HISTORIC PRESERVATION COMMISSION STAFF REPORT

APPLICATION: CA2017-08

TITLE: Certificate of Appropriateness CA2017-08; HL-107/MA-101
311 East Lemon Avenue

REQUEST: Review the exterior renovations on a single-family Craftsman residence which includes new wood shingles and clapboard siding, replacement of window and door surrounds, repair of overhanging eaves, rafter tails and gabled front porch roof. Review the exterior remodel of the rear (north) building elevation. The subject property is located in the RM3500 (Residential Medium Density) zone.

EXISTING ELEVATIONS
AND PROPOSED
MODIFICATIONS

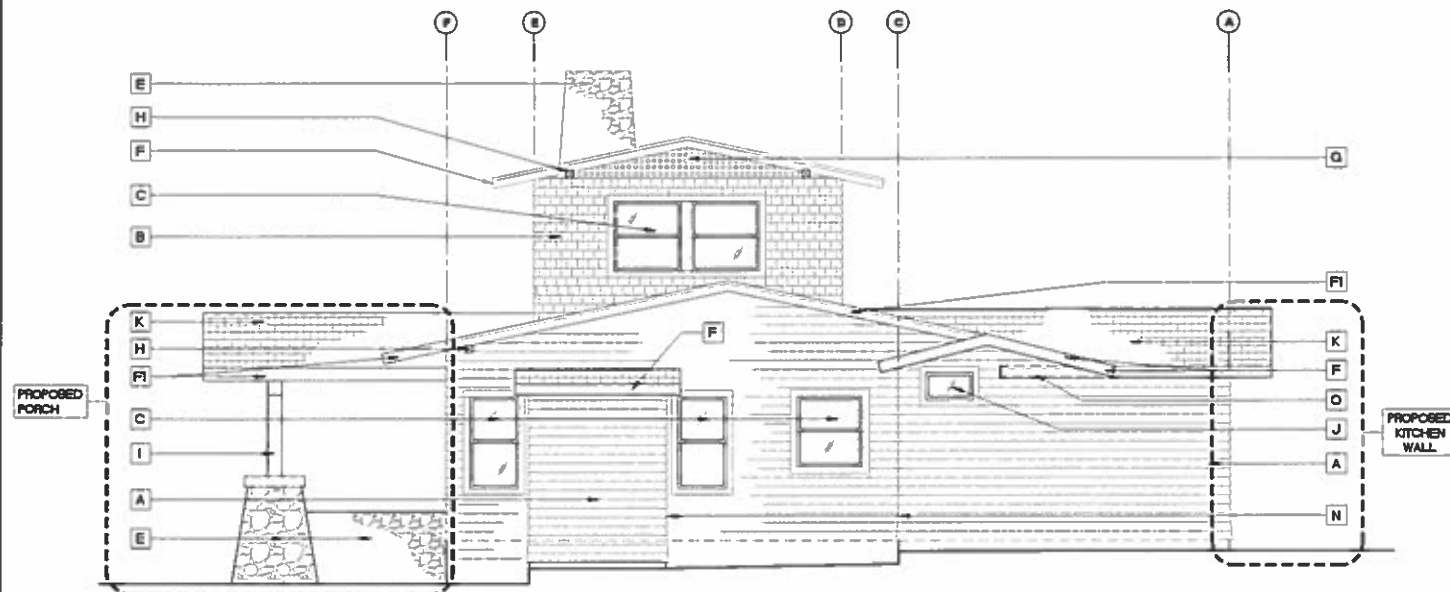
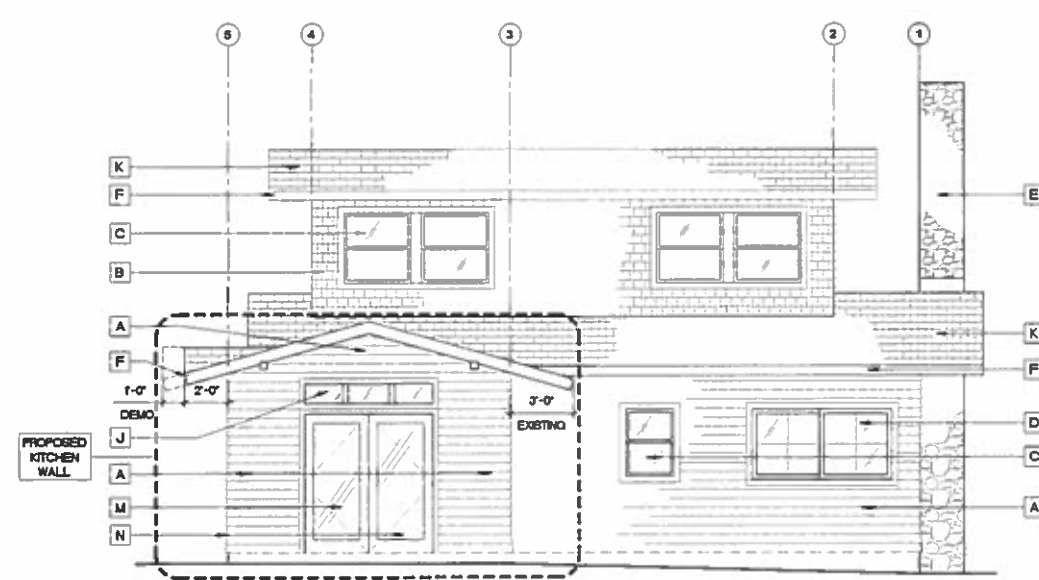
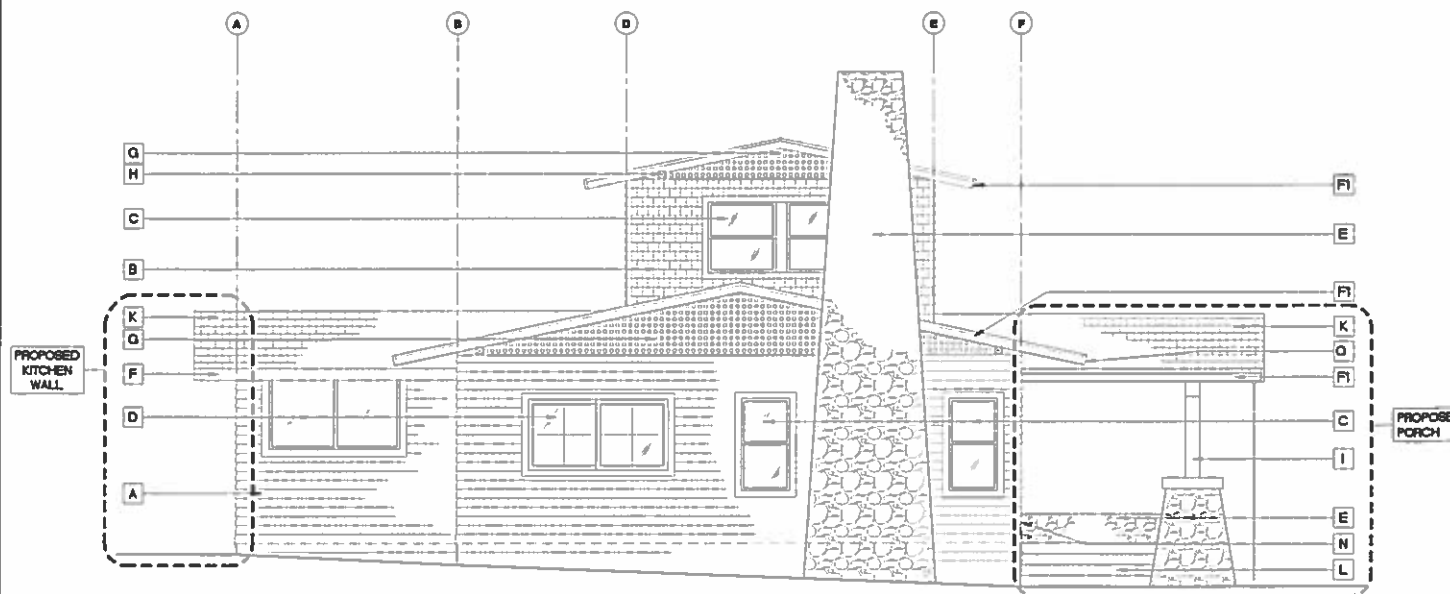
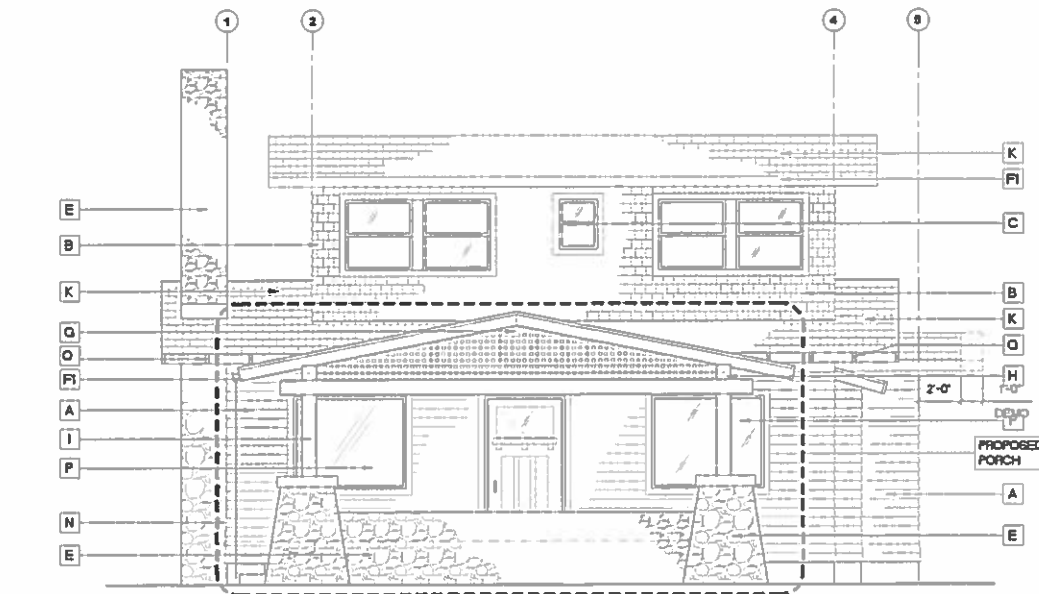
The revised architectural plans, attached as Exhibit “A,” clarify where construction has already taken place and where new alterations are being proposed. The building elevations on page A-4 have been labeled to clearly describe what areas on the residence will need to be reconstructed and the legend (Elevation Keynotes) clarifies what is existing and what is proposed. The reference to “proposed” includes the work that was previously done without permit.

The owner enlarged the kitchen by incorporating the rear porch into the floor plan, and in doing this revised the exterior building elevations. These alterations were reviewed by the Commission at the January 25th meeting. The Commission did not include the rear porch alterations under the CA2017-01 approval, and recommended that the design be revisited. The subcommittee met at the property and recommended that the fixed triangular windows under the eaves and the side lights on both sides of the French doors be removed on the north elevation. It was also recommended that the vinyl window on the west elevation be changed out to wood and that the recently added roof overhang on the east elevation be removed and the fascia be realigned. Although the proposed alterations do not return the rear porch to its

original exterior, the recommended revisions by the subcommittee removes the modern elements and simplifies the design which is in keeping with the Craftsman style.

- O** REMOVE RECENTLY ADDED OVERHANG AND CORRECT FACIA
- P** EXISTING FIXED GLASS
- Q** EXPOSED RAFTER TAILS TO BE REPLACED IN KIND

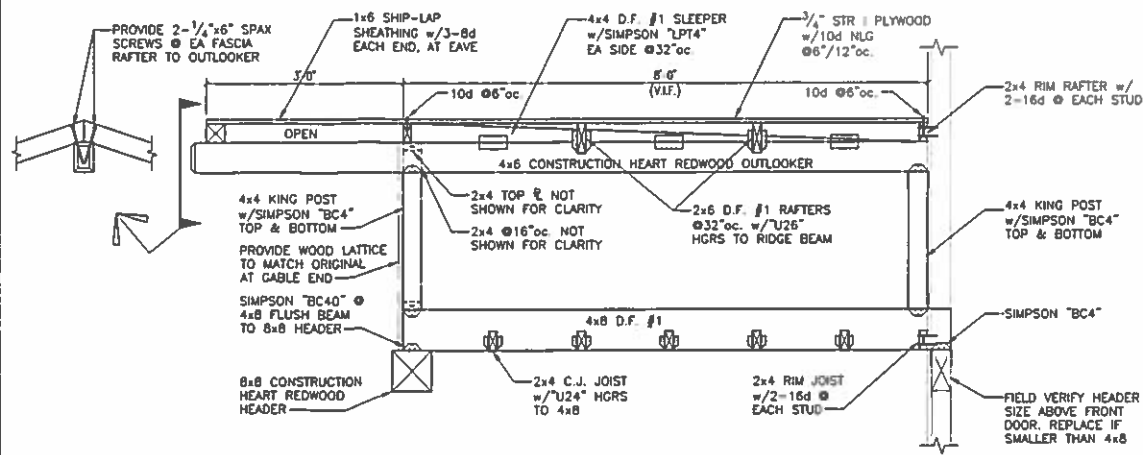
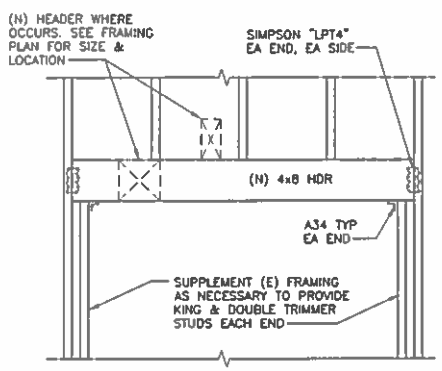
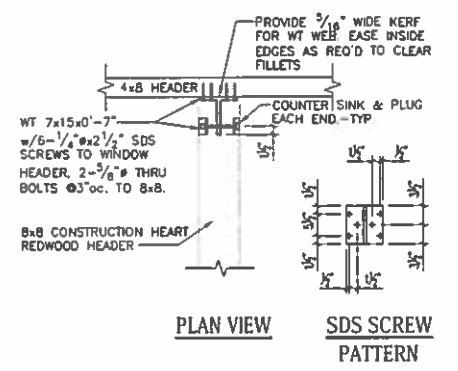
The reconstruction of the front porch (south elevation) will replicate what was demolished with the exception of raising the height of the beadboard ceiling from 7'-4" to 8'-1". The subcommittee reviewed this revision and believed it was still in keeping with the Craftsman design and would not be apparent from street view. The river rock porch base is intact and will not be altered. The structural details depicting support post size, porch roof design, and materials are shown on pages S-1 and S-2 of the plans.
